**Re: Dragon Products Company, Inc.
Quarry 5 Wastewater Reroute Project
Response**

On March 1, 2023, the Department responded via E-mail (Parker to Martunas) requesting additional information on the installation design of the new piping. The following paragraphs address the Department's requests and provide additional details of the installation.

FIGURE 1
 WASTEWATER PIPELINE
 MODIFICATION PLAN
 DRAGON PRODUCTS
 CKD STORAGE PILE
 THOMASTON, MAINE

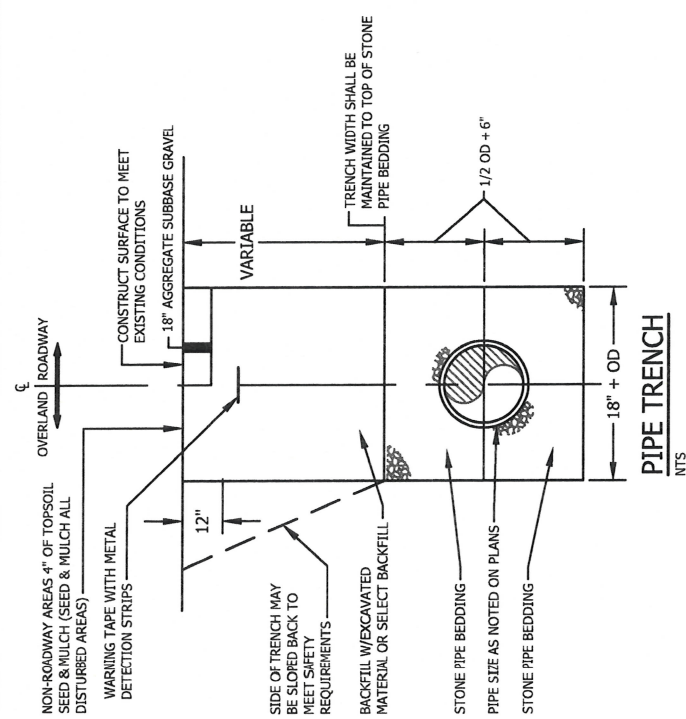
The narrative in the December 9, 2022 letter states that approximately 240 feet of 6-inch sewer line will be installed and connected to the southwestern end of the interceptor toe drain, with 75 feet of 6-inch High Density Polyethylene (HDPE) pipe under the onsite railroad tracks. Figure 1 shows a proposed 8-inch diameter PVC wastewater pipe (versus 6-inch) and the drawing also doesn't include the HDPE pipe under the railroad tracks or give a detail on how the two pipe types (PVC and HDPE) will be connected. Clarification should be provided.

The narrative provided on December 9, 2022 correctly identifies the piping size to be connected to the interceptor toe drain. Dragon will install a 6" line from the existing sewer pipe and connect to the existing 6 inch interceptor trench pipe. Figure 1 inadvertently indicates an 8 inch pipe connecting to the 6 inch interceptor trench. Figure 1 does show where the new piping will cross under the railroad tracks, however the tracks are not clearly labeled. A revised Figure 1 has been included with this submittal.

The existing sewer pipe is an 8 inch PVC ASTM D 3034 “green” pipe. A section of this pipe will be removed and a sanitary “Y” section installed. Downstream of the “Y” an 8” valve will be installed to prevent flow to the existing pump station. After the installation of the “Y” the 8” sewer pipe will be reduced to 6” and a 6” valve will be installed in the new section of pipe to prevent flow to the interceptor trench if needed. See Figure 1.

FIGURE 2
WASTEWATER PIPELINE
MODIFICATION DETAILS
DRAGON PRODUCTS
CKD STORAGE PILE
THOMASTON, MAINE

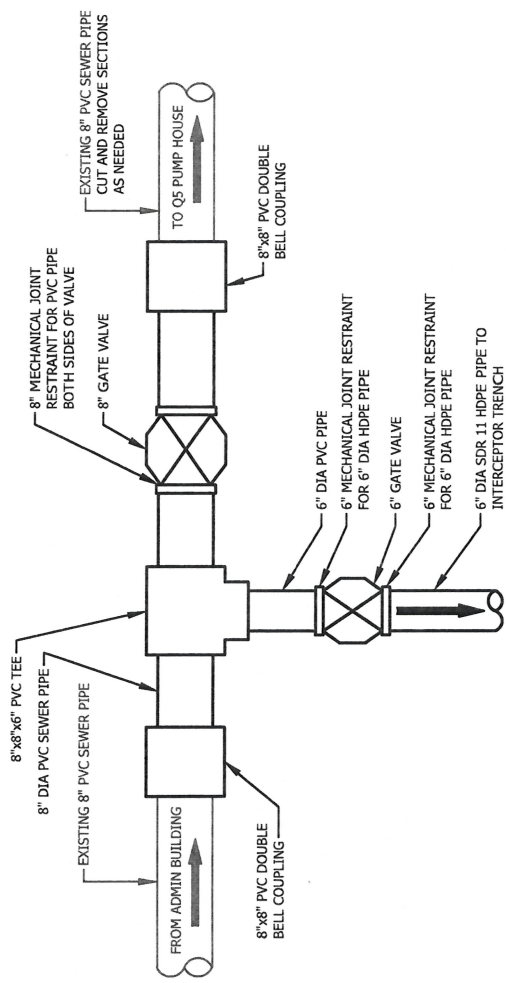
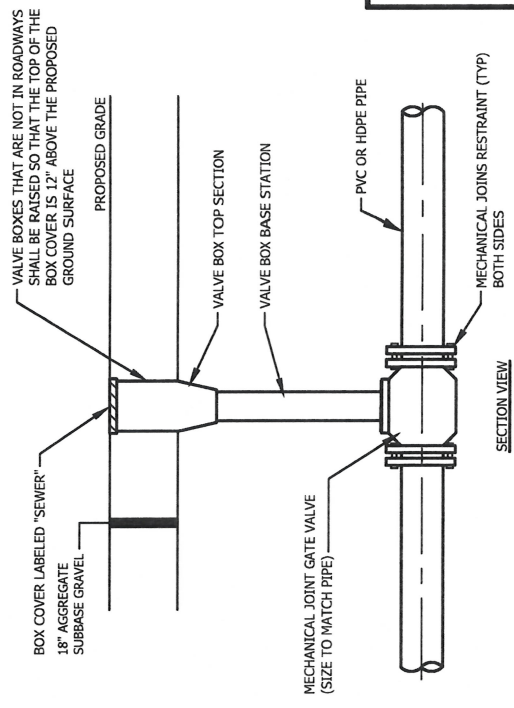
Additional clarification should be provided on how the gate valves will be accessed and whether, in the long term, there are any plans to plug the existing wastewater pipe section that currently

flows to the sump/pumphouse or will it remain just valved if the proposed rerouting is successful.

Dragon will install a short section of ASTM D 3034 sewer pipe to connect to the piping being directionally bored under the railroad tracks. The piping to be installed under the tracks is High Density Polyethylene (HDPE) DR 11 pipe. This is the same piping material used in the interceptor trench. The end of the HDPE pipe will be fitted with a 6 inch stainless steel male threaded fitting. See Attachment No. 1, Photo 1. A female threaded PCV fitting will connect the sewer pipe to the HDPE pipe.

The remainder of the pipe will consist of 6 inch HDPE pipe and will connect to the 6” interceptor trench pipe. Since both pipes are made of the same material, electrofusion couplings will be used to make the final connection. See Attachment No. 1., Photo 2. The interceptor trench pipe terminates with a 6 inch cleanout and Dragon will remove the cleanout, install a new HDPE “Y” section and connect the new HDPE pipe to the “Y”. The cleanout will be reinstalled and remain functional. Additional information on the valves and pipe connections is detailed in Figure 2.

Dragon will install steel risers over the gate valves that will extend approximately 12” above grade. See Attachment No. 1, Photo 3. The risers will provide access to the valves that can be manually opened or closed via a “T” handled valve tool. The risers will be barricaded for protection.
